Addendum No. 2 **Issued: November 6, 2026**

Project Name: Pottsgrove High School
Facilities & Athletic Improvements
ICS Project No. S25009

Project Owner: Pottsgrove School District
1301 Kauffman Road
Pottstown, PA 19464

POWER PLAN - HOME SIDE PAVILION

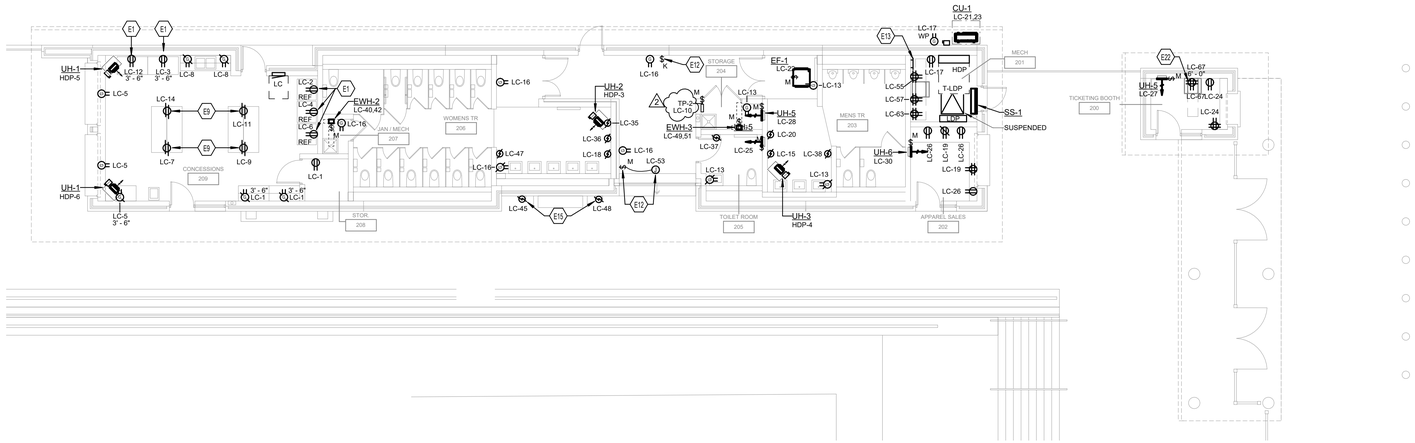
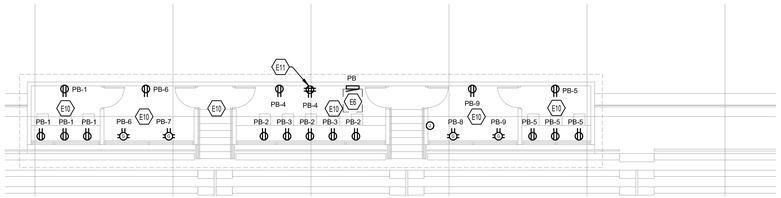
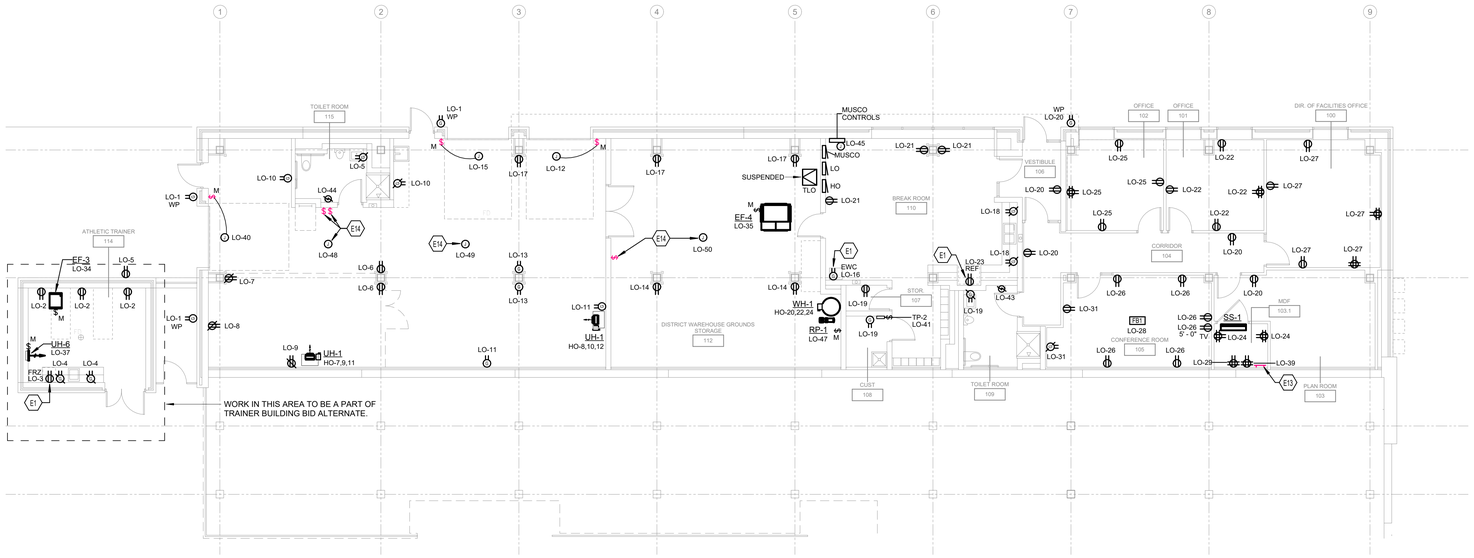
Revised Drawing E-201: Updated circuit for trap primer in Storage Room 204 – **1 page**

FIRE ALARM PLAN - HOME SIDE PAVILION

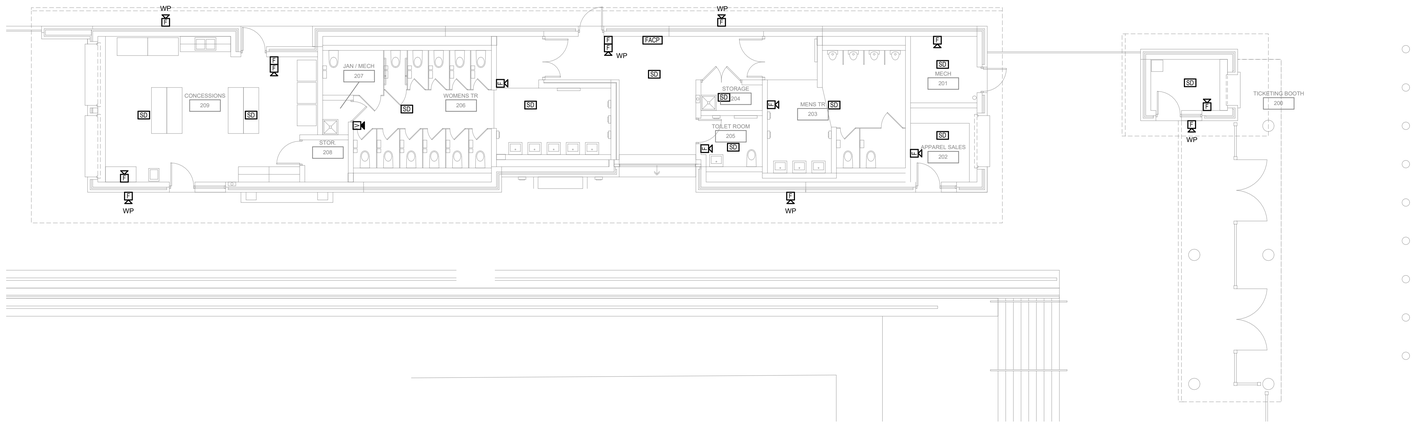
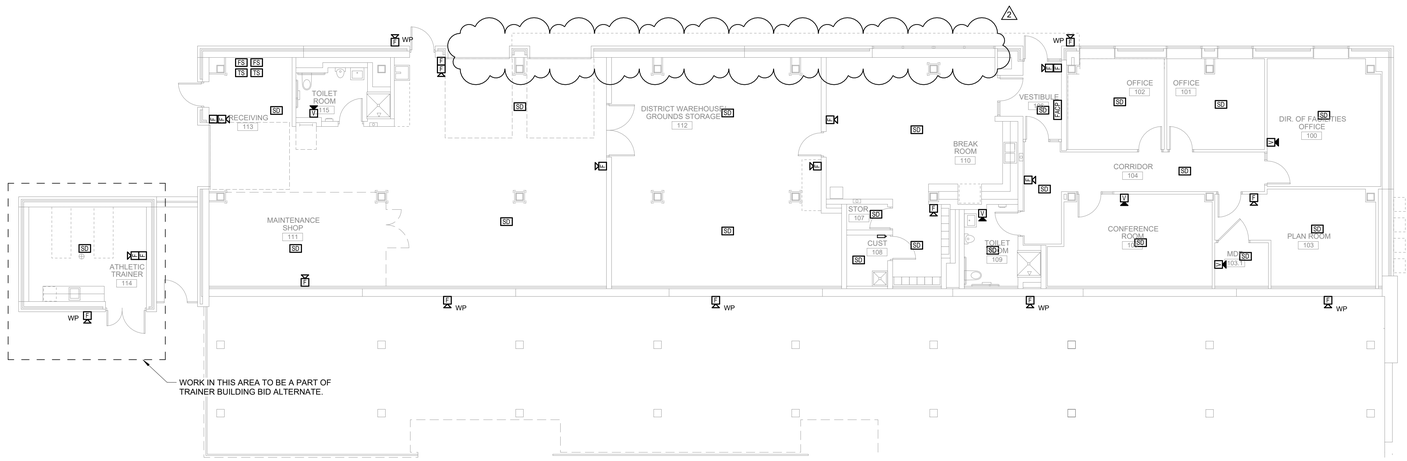
Revised Drawing E-301: Removed smoke detectors previously shown on North wall of Home Side area under bleachers – **1 page**

1 A2.1 FACILITY BUILDING / UNDER HOME BLEACHERS

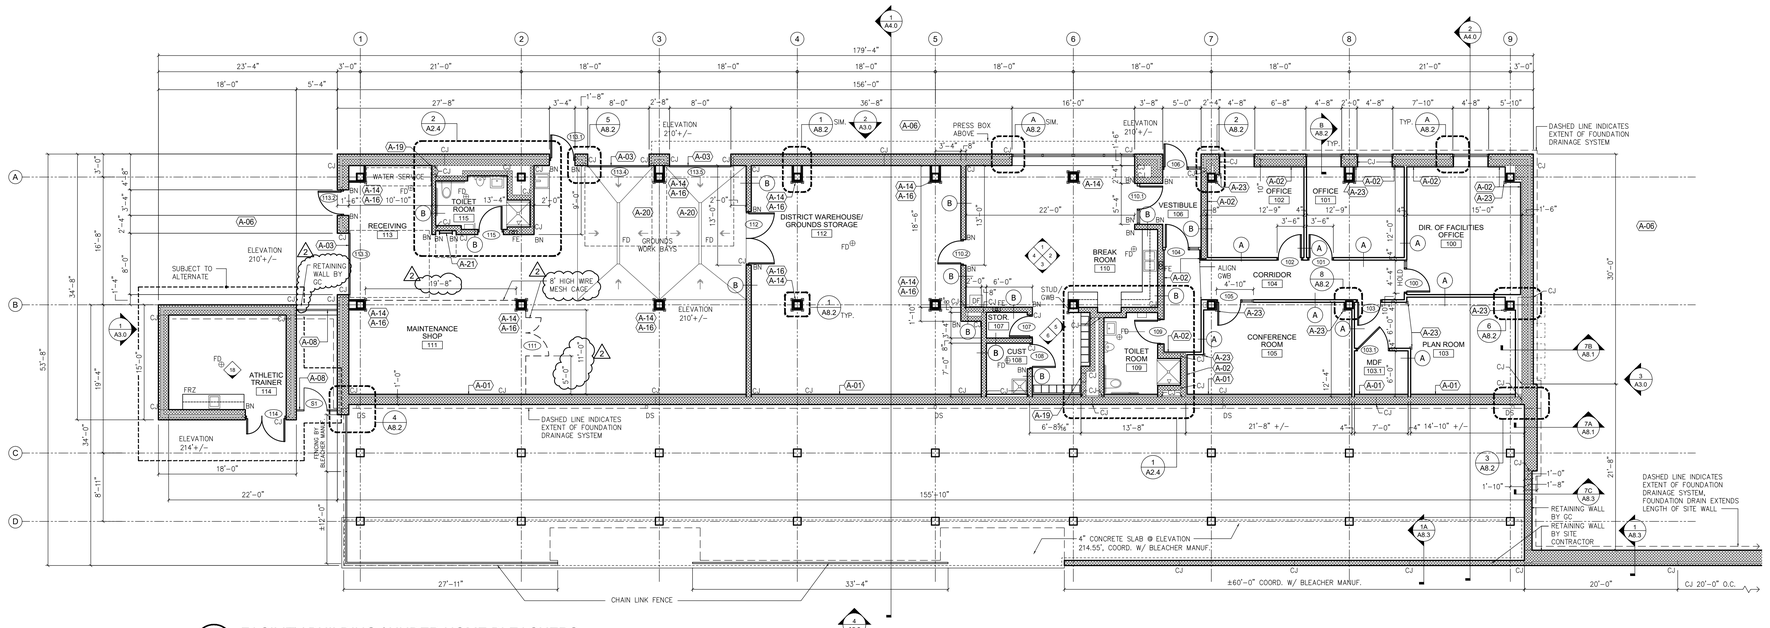
Revised Drawing A2.1: UNDER HOME BLEACHER & HOME BLEACHER PLAN, Detail 1/A2.1 FACILITY BUILDING / UNDER HOME BLEACHERS, Reference WIRE MESH Dimensions: - **1 page**

a. Section between Column Line 1&2 = 19'-8" (L) x 8'-0" (H)
b. Section between Column Line B & Retaining Wall = 11'-0" (L) x 8'-0" (H)
    1) This section includes a 5'-0" Opening Width for Gate/Door. Reference Dr. 111 on Schedule.
c. UNDER HOME BLEACHER & HOME BLEACHER PLAN, Detail 1/A2.1 FACILITY BUILDING / UNDER HOME BLEACHER, Reference Locations for "Scope coordination between Site Contractor and General Contractor". Reference attached Reissued Sheet A2.1 UNDER HOME BLEACHER & HOME BLEACHER PLAN.

1A A2.2 RAMP & STAIR DETAIL
SCALE: 1/8" = 1'-0"

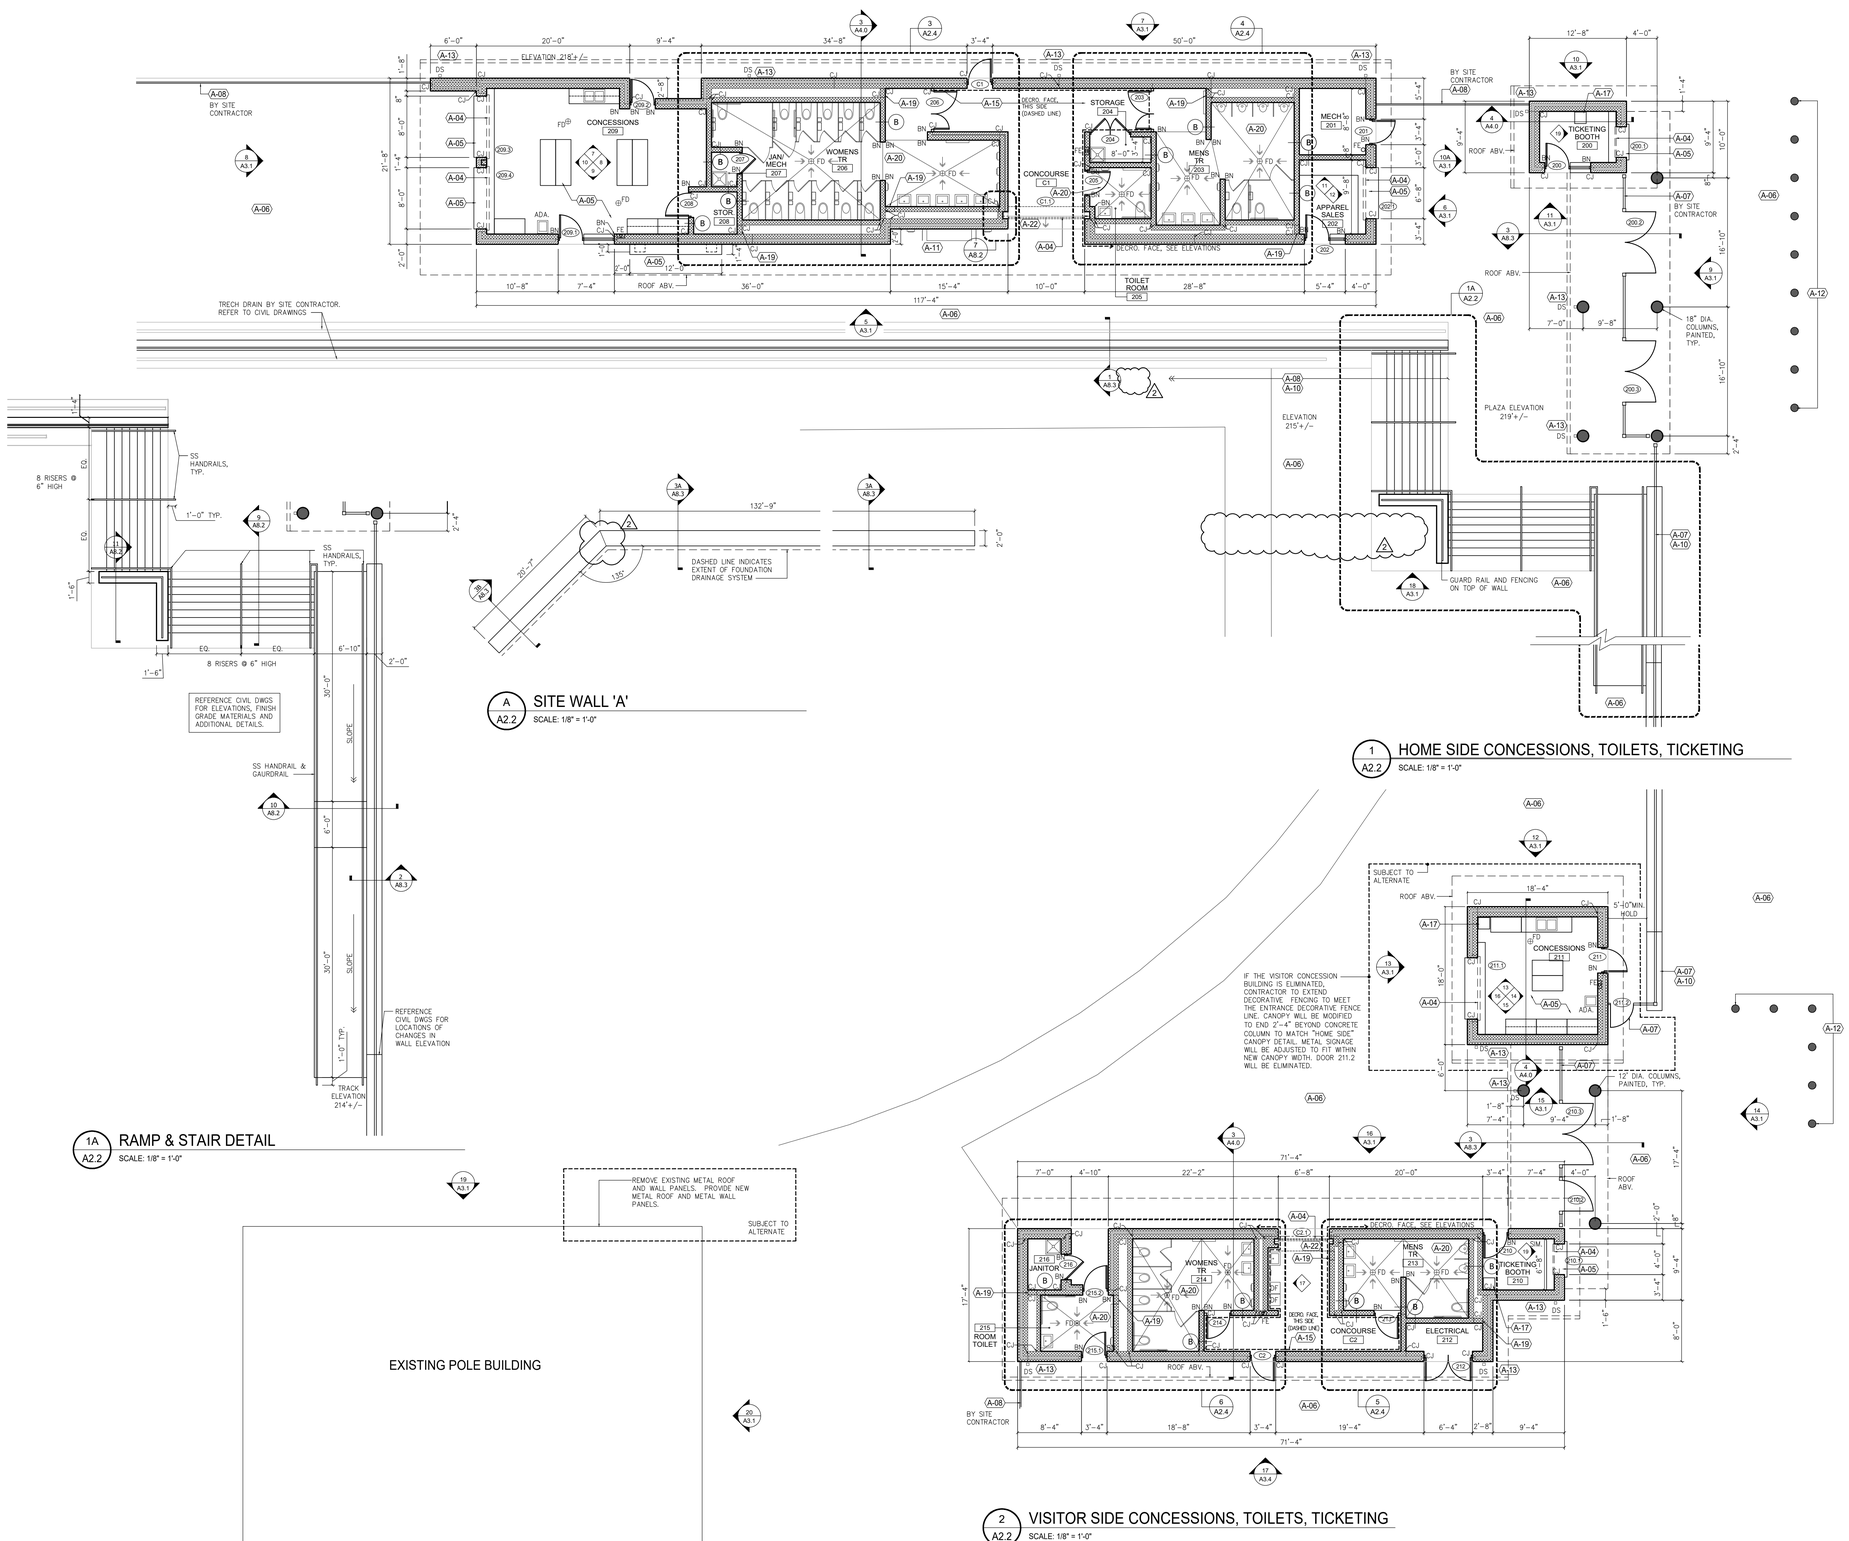
Revised Drawing A2.2: CONCESSION, TOILETS, & TICKETING PLANS – Reference re-issued drawing for the following items: - **1 page**

- Detail 1A/A2.2, RAMP & STAIR DETAIL: Remove "Flag Pole from this location" – Reference CIVIL DWGS for New Location of Flag Pole.
- Detail 1/A2.2, HOME SIDE CONCESSIONS, TOILETS, TICKETING, Remove Floor Plan Key Note "A18" from plan.
- Detail A/A2.2, SITE WALL 'A', ADD line to distinguish change in elevation.

7A A8.1 RETAINING WALL
SCALE: 3/4" = 1'-0"

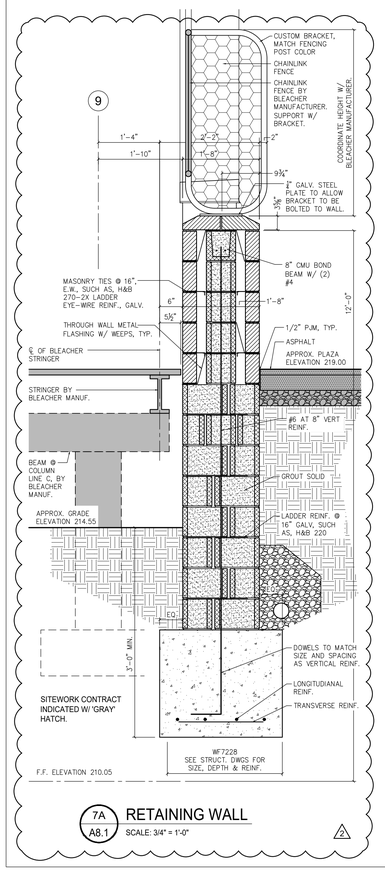
- Detail 7A/A8.1
    a. Change note "8" CMU BOND BEAM" to "8" CMU BOND BEAM W/ (2) #4"
    b. Change note "VERT REINF." to "#6 AT 8" VERT REINF."
    c. Change note "SEE STRUCT. DWGS FOR SIZE, DEPTH & REINF." to "WF7228 SEE STRUCT. DWGS FOR SIZE, DEPTH & REINF."
    d. Remove 'Gray' Hatch from foundation & CMU wall construction
    e. ADD general note:
        1) "SITEWORK CONTRACT INDICATED W/ 'GRAY' HATCH."

3 A8.2 **PLAN DETAIL**
SCALE: 1 1/2" = 1'-0"

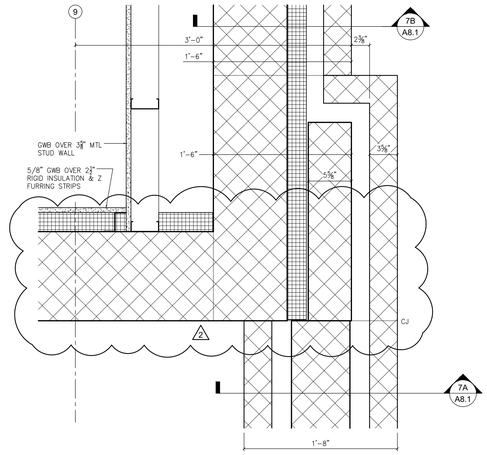
- Detail 3/A8.2
    a. Remove stray horizontal line
    b. ADD CJ located at change in CMU block thicknesses – Reference attached Reissued Drawing
- Detail 9/A8.2
    a. Flagpole to be relocated, refer to civil drawings for new location. Remove 50' flagpole & all corresponding notes:
        1) "50' FLAGPOLE, REFERENCE CIVIL DWGS FOR FOUNDATION DETAILS"
    b. ADD general note:
        1) "CONSTRUCTION PART OF SITEWORK CONTRACT INDICATED W/ 'GRAY' HATCH."
- Detail 10/A8.2
    a. ADD general note:
        1) "CONSTRUCTION PART OF SITEWORK CONTRACT INDICATED W/ 'GRAY' HATCH. GC TO FURNISH DECORATIVE CMU."
- Detail 11/A8.2
    a. Correct font of the following note, adjust drawing:
        1) "MASONRY TIES @ 16", E.W., SUCH AS, H&B 270-2X LADDER EYE-WIRE REINF., GALV."
    b. Correct font of the following note, adjust drawing:

9 A8.2 **SITE STAIR DETAIL**
SCALE: 1/2" = 1'-0"

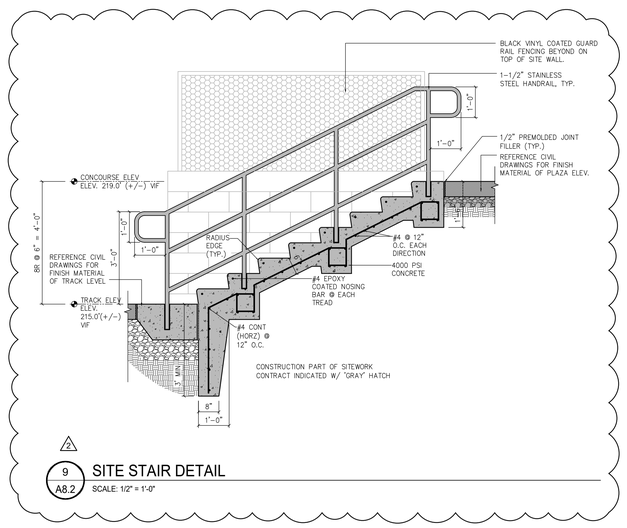
1) "F.F. ELEVATION 210.05"

c. Change bottom three decor. CMU courses, below stair, to show solid CMU grouted construction.

d. Change note "8" CMU BOND BEAM" to "8" CMU BOND BEAM W/ (2) #4"

e. ADD the following note and point to vertical reinforcing:
   1) "#5 AT 8" VERT REINF"

f. Change note "SEE STRUCT. DWGS FOR SIZE, DEPTH & REINF." to "WF3628 SEE STRUCT. DWGS FOR SIZE, DEPTH & REINF."

g. Flagpole to be relocated, refer to civil drawings for new location. Remove 50' flagpole, flagpole lighting, flagpole foundation, & all corresponding notes:
   1) "50' FLAGPOLE"
   2) "LIGHT FIXTURE BY EC"
   3) "FLAGPOLE FOUNDATION PER MANUF. SPEC – REFER TO CIVIL DWGS FOR INFORMATION."

h. ADD general note:
   1) "WALL CONSTRUCTION PART OF SITEWORK CONTRACT, INDICATED W/ 'GRAY' HATCH. GC TO FURNISH DECORATIVE CMU"

i. Reference addition of dimensions:
   1) From Concourse Elevation +/- 219.0' to top of guardrail = 3'-7"
   2) From top of site wall to top of guardrail = +/- 3'-3"

1 A8.3 **RETAINING WALL @ TRACK & CONCOURSE**
SCALE: 3/4" = 1'-0" WALL CONSTRUCTION PART OF SITEWORK CONTRACT, INDICATED W/ 'GRAY' HATCH. GC TO FURNISH DECORATIVE CMU 2

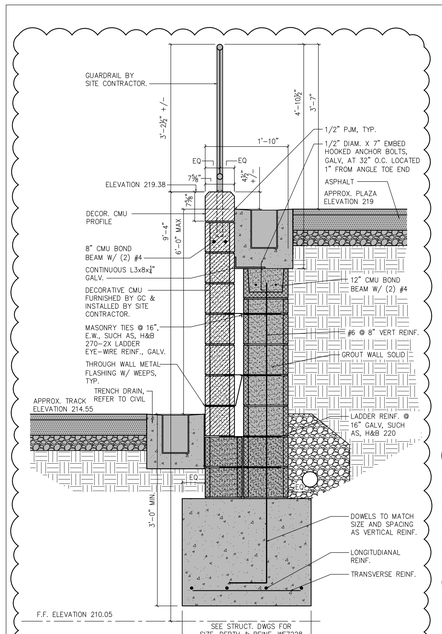
- Detail 1/A8.3
  a. ADD anchor bolts and the following note pointing to angle on top of 12" bond beam:
     1) "1/2" DIAM. X 7" EMBED HOOKED ANCHOR BOLTS, GALV, AT 32" O.C. LOCATED 1" FROM ANGLE TOE END"

b. ADD the following note pointing to the 2nd course from the top of the decorative CMU wall and change to bond beam:
     1) "8" CMU BOND BEAM W/ (2) #4"

c. Change Note "#5 @ 8" VERT REINF." To "#6 AT 8" VERT REINF."
  d. Change Note "SEE STRUCT. DWGS FOR SIZE, DPETH & REINF. WF6028" to "SEE STRUCT. DWGS FOR SIZE, DEPTH & REINF. WF7228"

e. Adjust the following note to point to L angle above 12" CMU:
     1) "CONTINOUS L3x8x1/4" GALV."
  f. Change note from "WALL CONSTRUCTION PART OF SITEWORK CONTRACT. GC TO FURNISH DECORATIVE CMU" to "WALL CONSTRUCTION PART OF SITEWORK CONTRACT, INDICATED W/ 'GRAY' HATCH. GC TO FURNISH DECORATIVE CMU"

g. Adjust positioning of misc. notes to fit additional notes.
- Detail 1A/A8.3
  a. Change sidewalk drawings to match Detail F9/S3.2 and ADD the following note pointing to sidewalk:

1A A8.3 **SITE WALL @ RAMP**
SCALE: 3/4" = 1'-0" 2

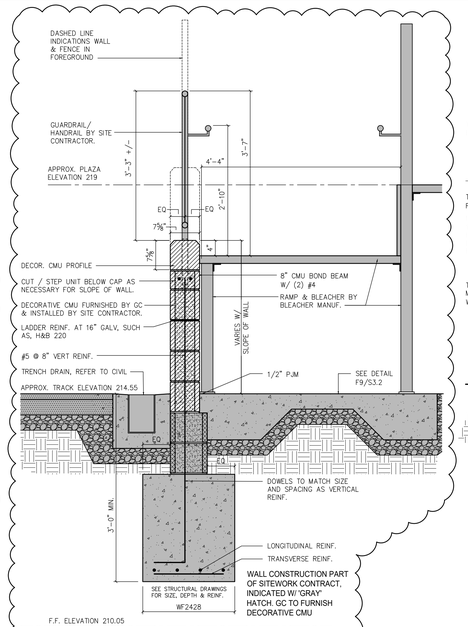
1) "SEE DETAIL F9/S3.2"
  b. The following note to additionally point to ramp structure:
     1) "RAMP & BLEACHER BY BLEACHER MANUF."
  c. Adjust vertical reinforcing to be centered in 8" CMU

1) Note pointed to vertical reinforcing to follow

d. Change note from “WALL CONSTRUCTION PART OF SITEWORK CONTRACT. GC TO FURNISH DECORATIVE CMU” to “WALL CONSTRUCTION PART OF SITEWORK CONTRACT, INDICATED W/ ‘GRAY’ HATCH. GC TO FURNISH DECORATIVE CMU”

2 A8.3 **RETAINING WALL @ FRONT ENTRY**
SCALE: 3/4" = 1'-0"

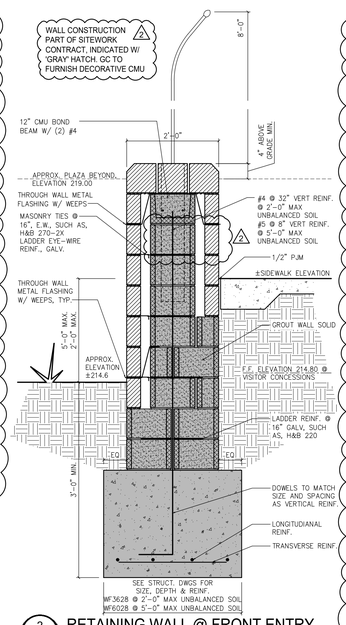
- Detail 2/A8.3
  a. Remove additional through wall flashing
  b. ADD general note “WALL CONSTRUCTION PART OF SITEWORK CONTRACT, INDICATED W/ ‘GRAY’ HATCH. GC TO FURNISH DECORATIVE CMU”

7C A8.3 **RETAINING WALL**
SCALE: 3/4" = 1'-0" 2

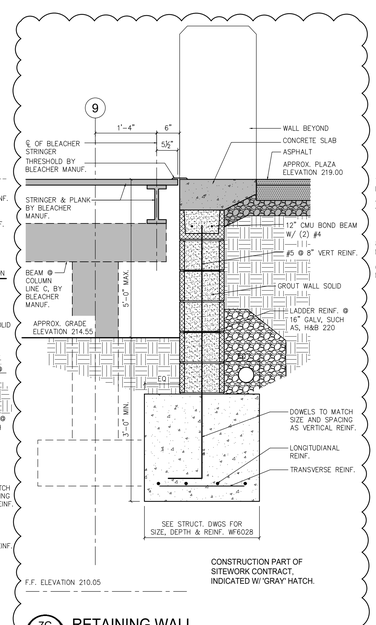
- Detail 7C/A8.3
     1) Remove L8 from top of site wall construction & corresponding note:
        a) “L8”x4”x3/8” GALV.”
  b. Adjust concrete & stone – Reference attached Reissued Drawing

c. Remove ‘Gray’ Hatch from foundation & CMU wall construction
  d. ADD general note “CONSTRUCTION PART OF SITEWORK CONTRACT, INDICATED W/ ‘GRAY’ HATCH.”

3B A8.3 **RETAINING WALL @ REAR ENTRY**
SCALE: 3/4" = 1'-0" 2

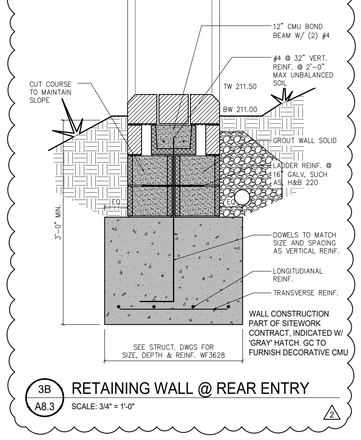
- Detail 3B/A8.3
  a. ADD foundation drain
  b. ADD general note “WALL CONSTRUCTION PART OF SITEWORK CONTRACT, INDICATED W/ ‘GRAY’ HATCH. GC TO FURNISH DECORATIVE CMU”

3A A8.3 **RETAINING WALL @ REAR ENTRY**
SCALE: 3/4" = 1'-0" 2

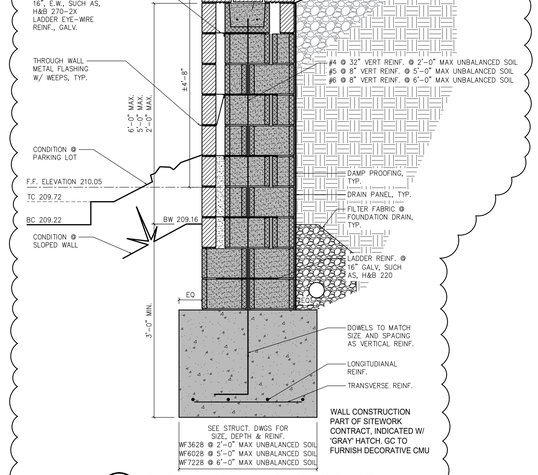
- Detail 3A/A8.3
  a. ADD grout behind veneer below grade
  b. Addition of the following notes:
     1) Add the following note pointing to right / back of site wall below grade:

a) “DAMP PROOFING, TYP.”
     2) Add the following note pointing to right / back of site wall below grade:
        a) “DRAIN PANEL, TYP.”
     3) Add the following note pointing to foundation stone fill around foundation drain

a) “FILTER FABRIC @ FOUNDATION DRAIN, TYP.”
  c. ADD general note “WALL CONSTRUCTION PART OF SITEWORK CONTRACT, INDICATED W/ ‘GRAY’ HATCH. GC TO FURNISH DECORATIVE CMU”
